# **FM 620 and Anderson Mill Road Wastewater Service Extension Request #4652**

**Environmental Commission Meeting  
April 21, 2021**

# SER #4652

# SER #4652 Proposed Wastewater Extension Option #1

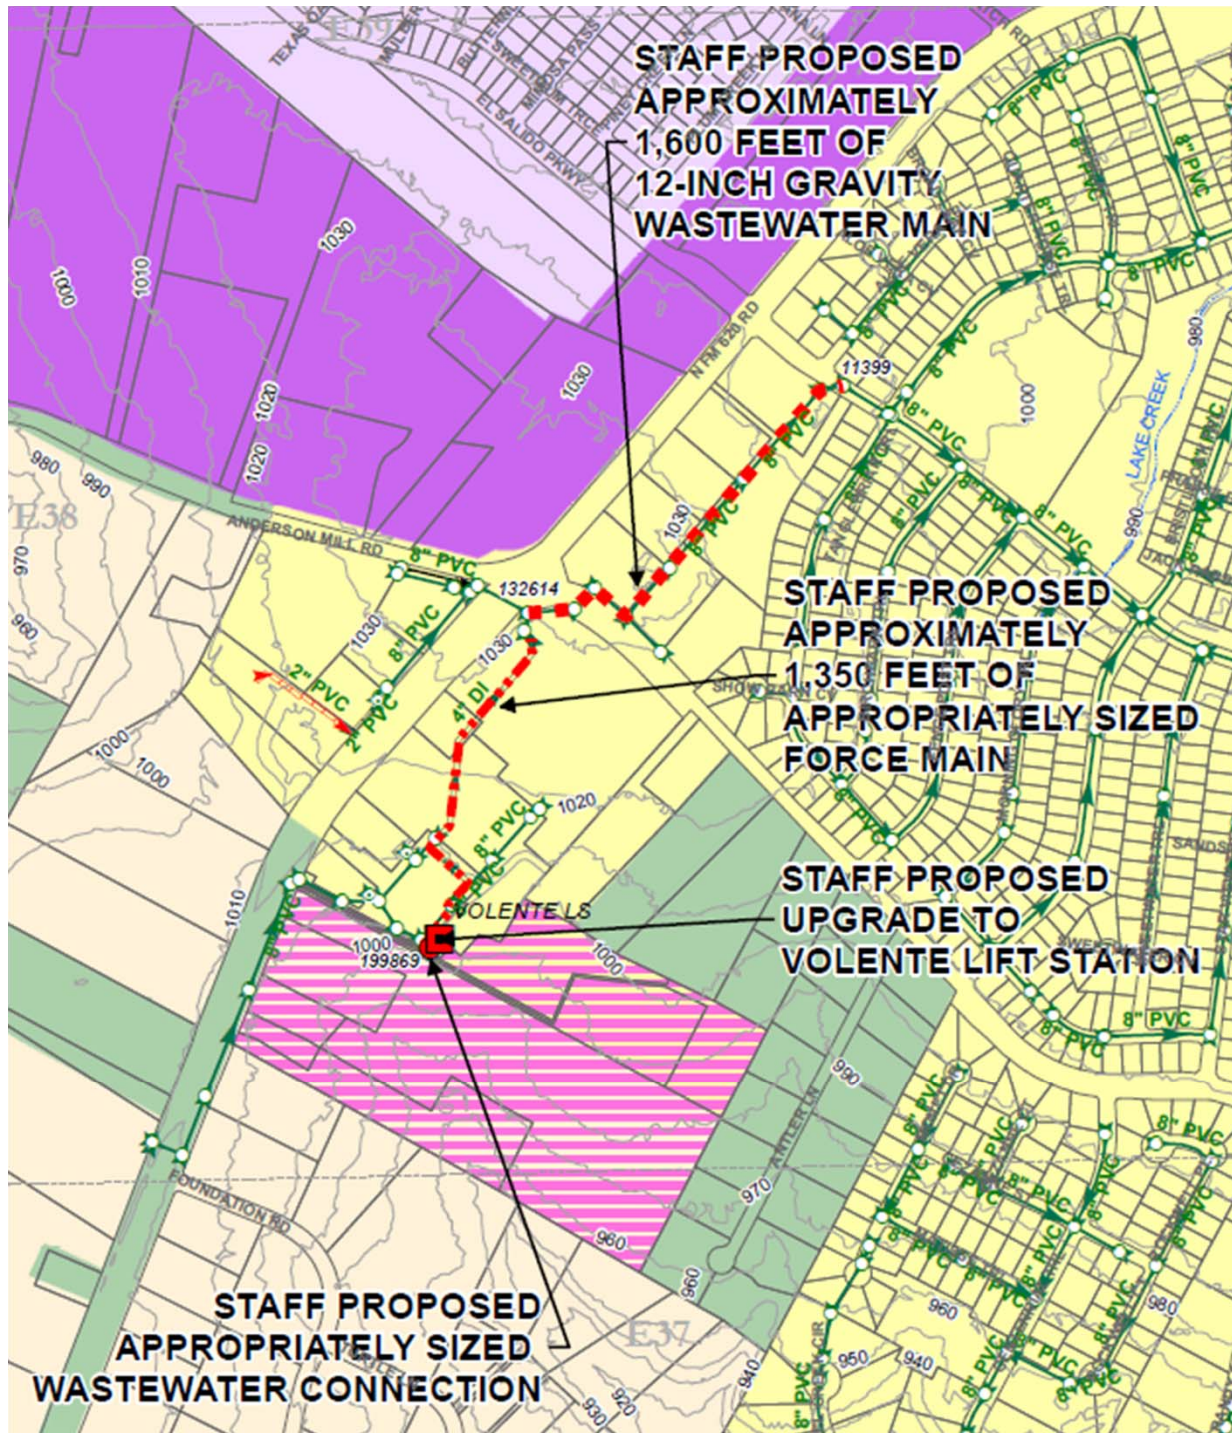
- Proposing to upgrade the existing Volente Lift Station, upgrade the existing force main that serves the lift station, and upgrade the downstream gravity collection system to provide the capacity necessary to serve the proposed development.
- Within Austin Water Service Area

- Headwaters tributary to Bull Creek
- Contains 2 springs, 1 karst recharge feature, and 4 wetlands
- Contains critical water quality zone & water quality transition zone to Bull Creek

- The site is at the headwaters of federally-listed threatened Jollyville Plateau salamander habitat.
- Through prior scientific studies, WPD biologists identified a robust population of salamanders in this tributary.
- Runoff from the development would flow downstream into habitat, and thus could negatively affect that salamander population.
- As the intensity of development on the site increases, the probability of harm to salamander increases.

**Staff does not recommend approval.**

Staff review determined that there are significant environmental risks to extend service to the site.
